OVERLAND FLOW REPORT STAGE 1

PROPOSED DEVELOPMENT: MAMRE WEST PRECINCT ORCHARD HILLS NSW

Project Title	Mamre Road, Erskine Park
Document Title	Overland Flow Report – Stage 1
Project No.	12042.00
Description	Overland flow assessment for new industrial development.
Client Contact	Mr Tim Ireson, Hansen Yuncken

8. PEER REVIEW

DTM COMPARISON

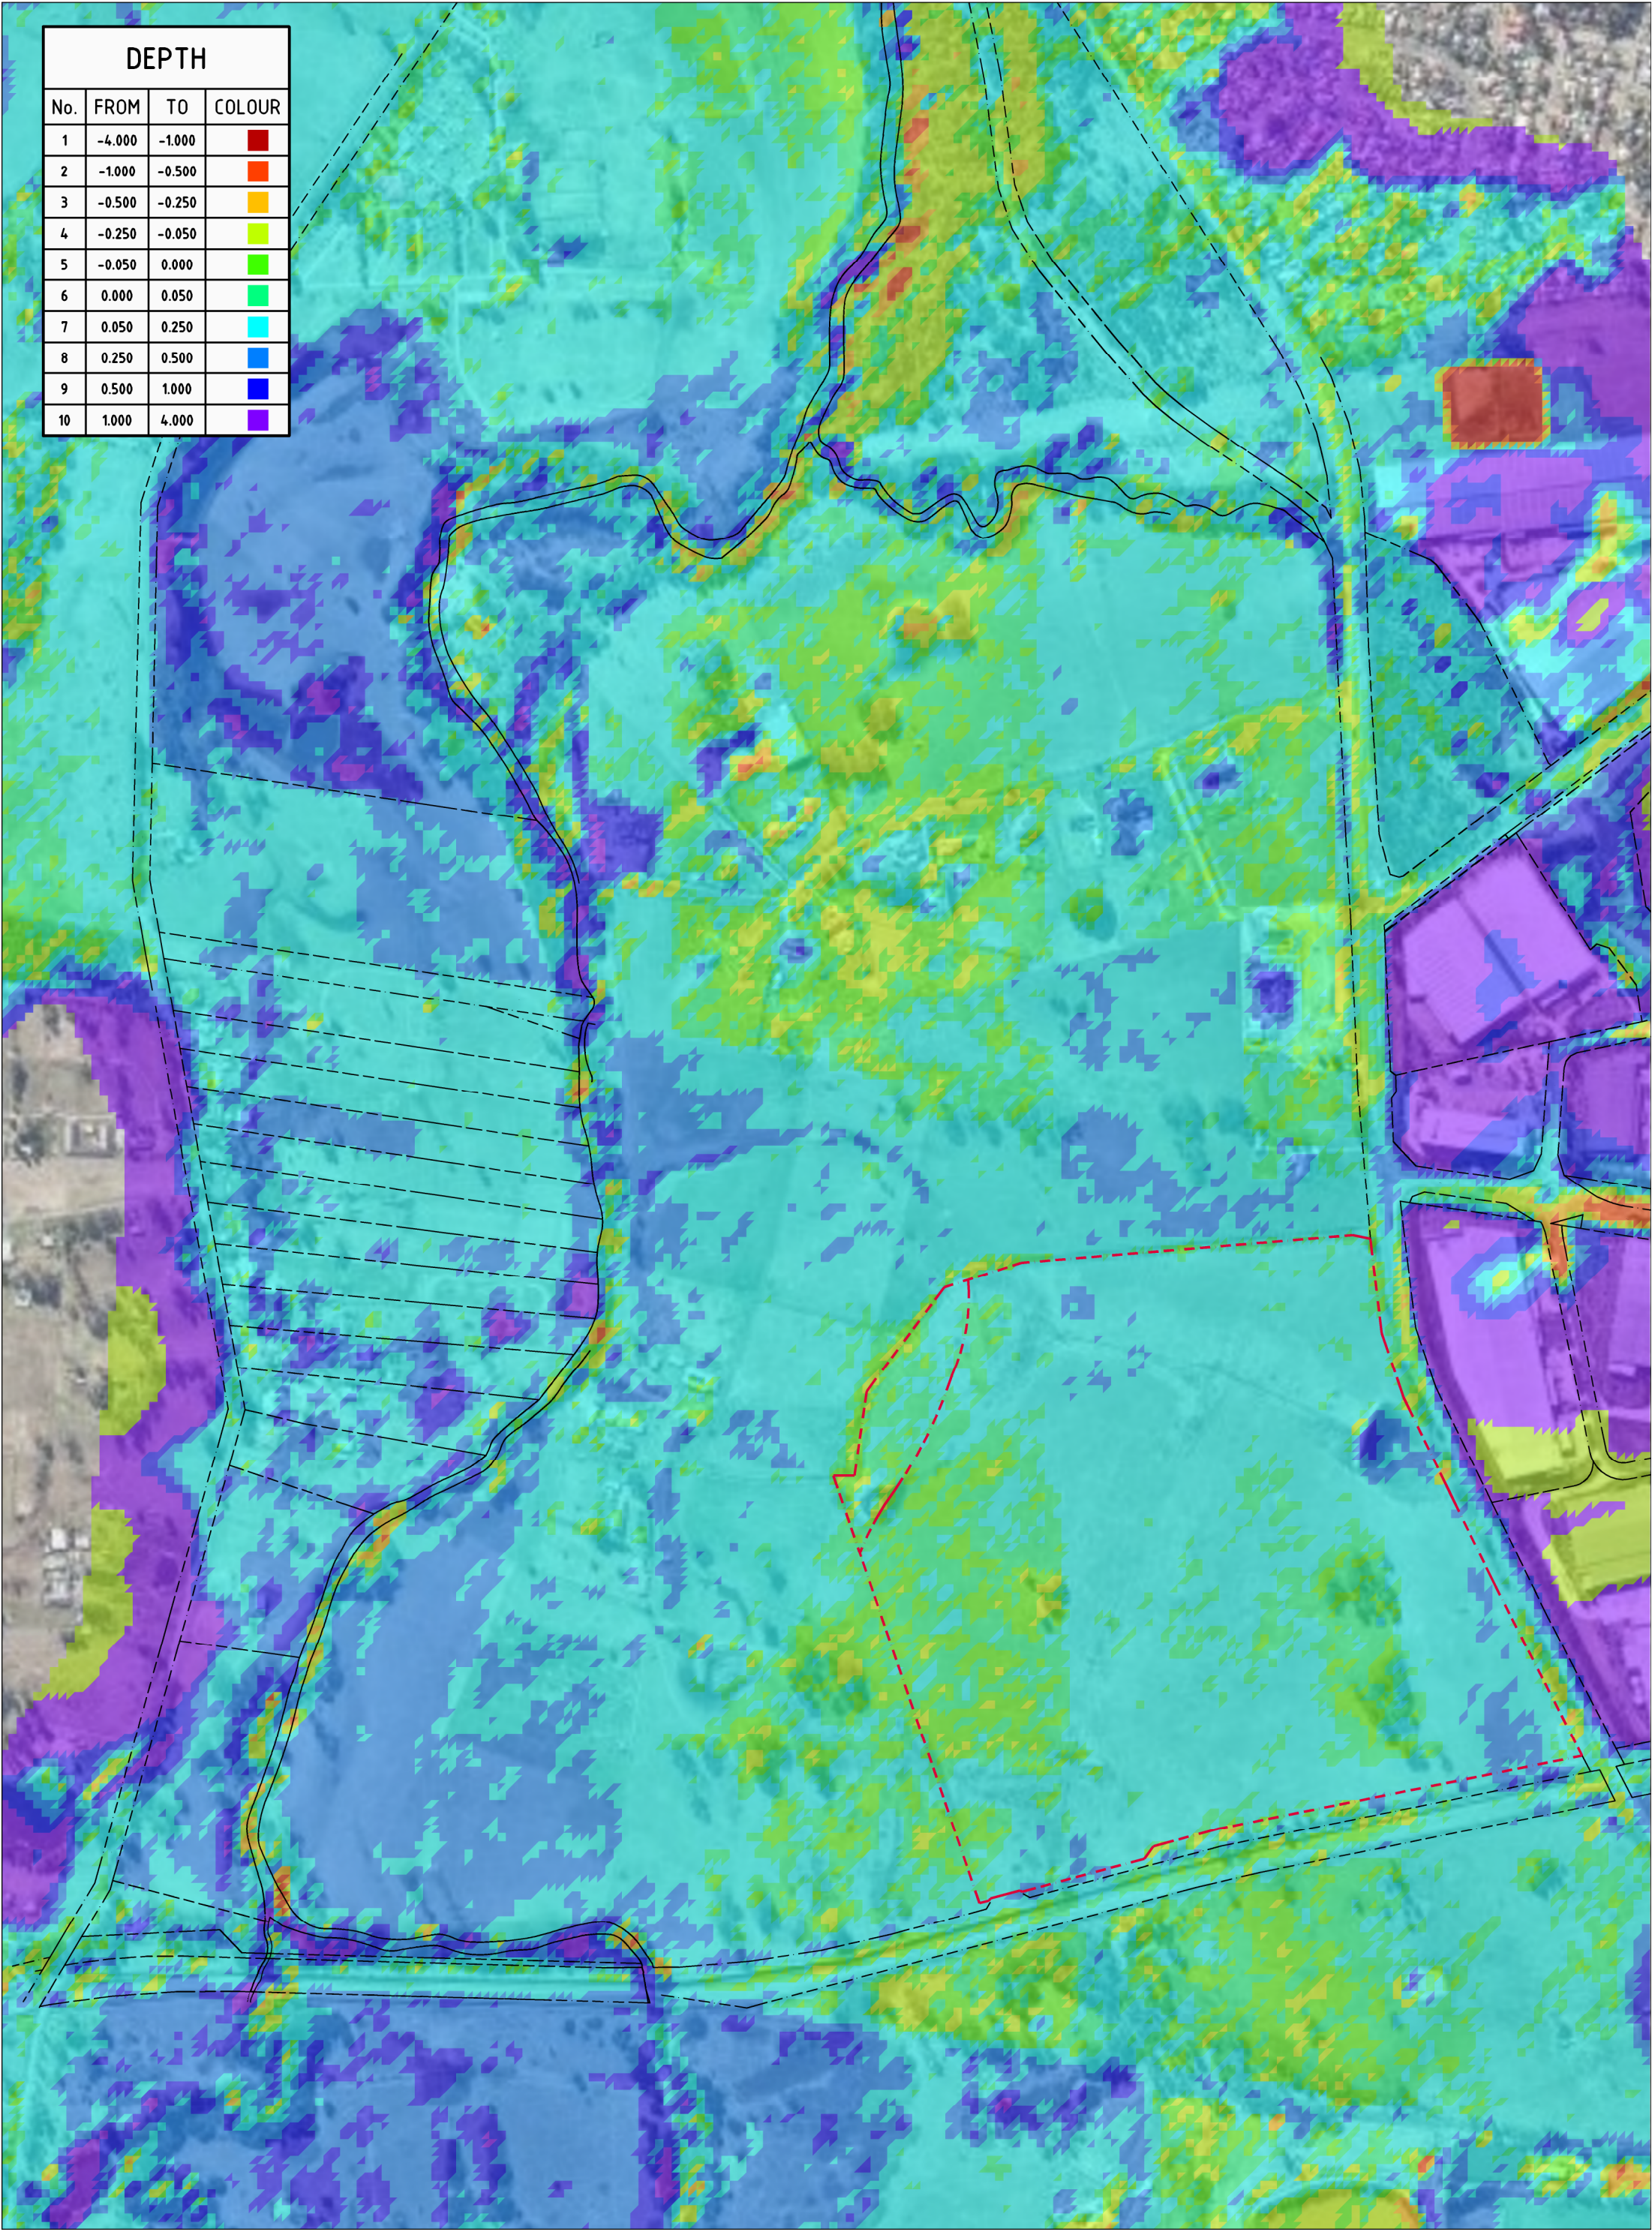
- Item B2 The set-up of the existing condition model appears consistent with the available topographic data. A figure showing the spatial variation in adopted land use types should be incorporated within the Overland Flow Report.*

Please refer to **Appendix D** of the report for DTM comparison.

UPSTREAM BOUNDARY SENSITIVITY RESULTS

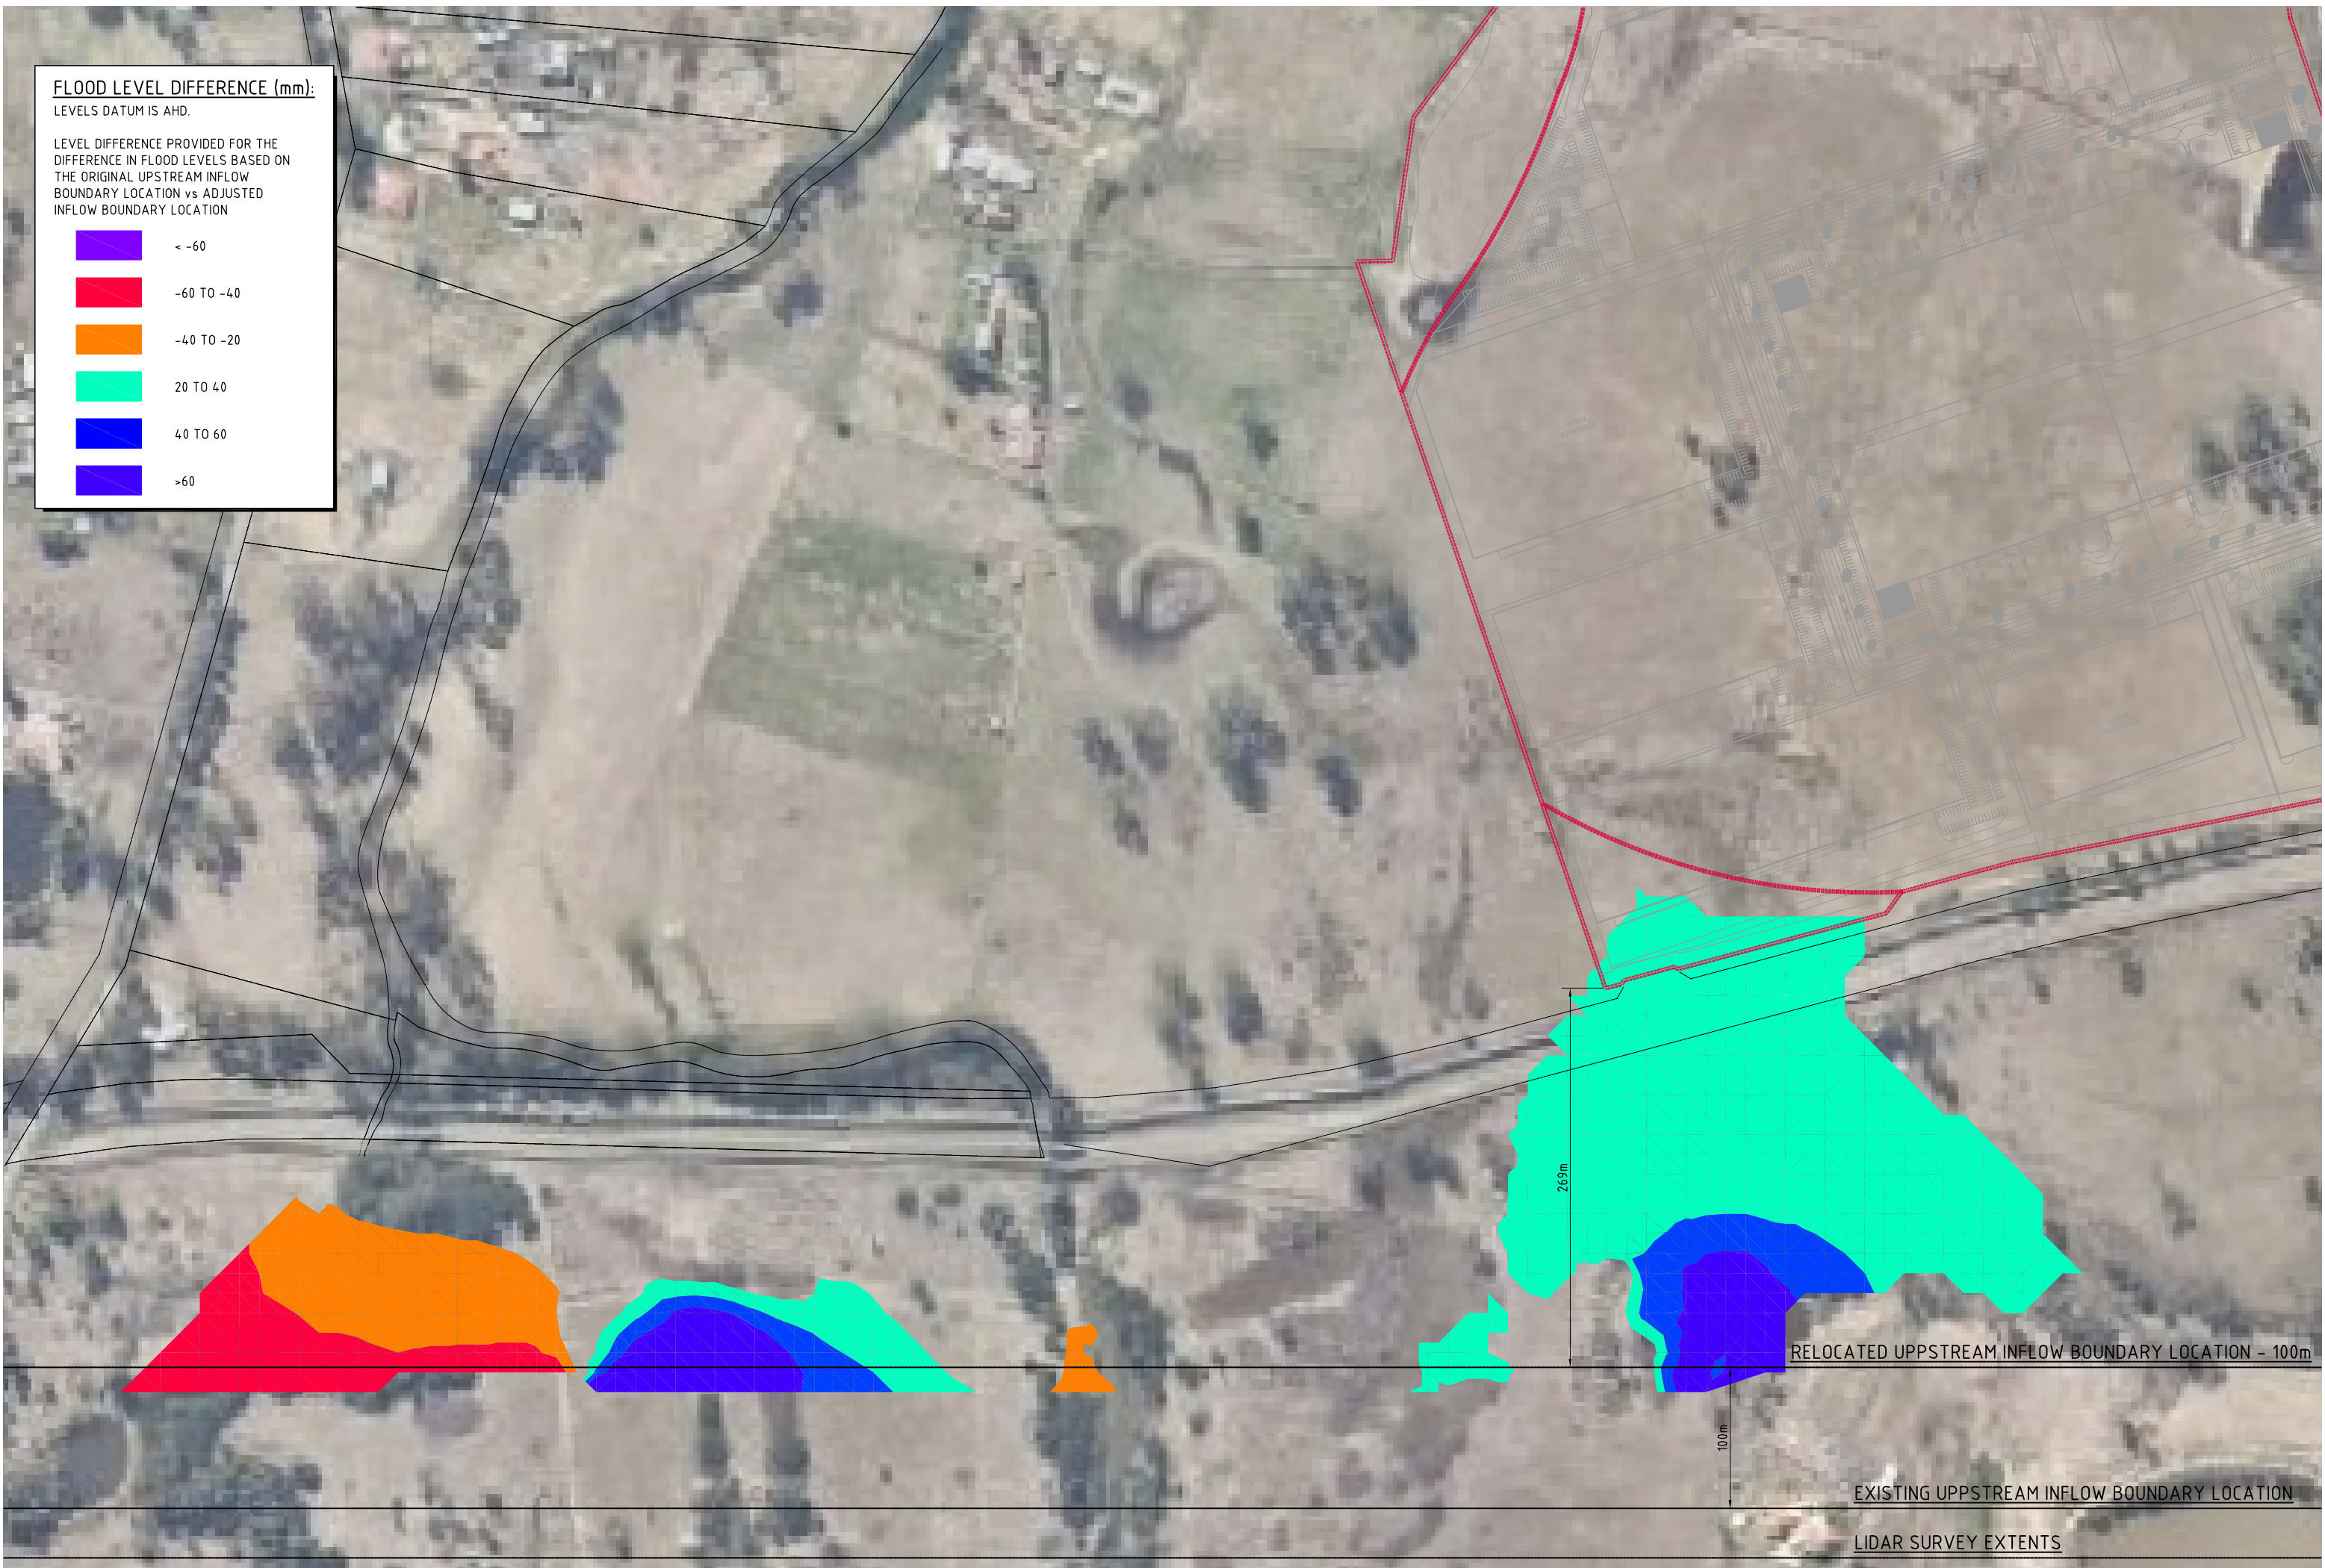
Item B1.b) The upstream boundary should be located a sufficient distance upstream to cover the extent of predicted impacts from the proposed development. It is unclear if sensitivity analysis has been undertaken to ensure the current set-up is satisfactory.

A sensitivity analysis has been undertaken which confirms the upstream boundary, located 400m from the property boundary, is sufficiently located far enough from the property to enable appropriate scenario testing relating to the proposed development.

Please refer to **Section 6.2** and **Appendix E** of the report.
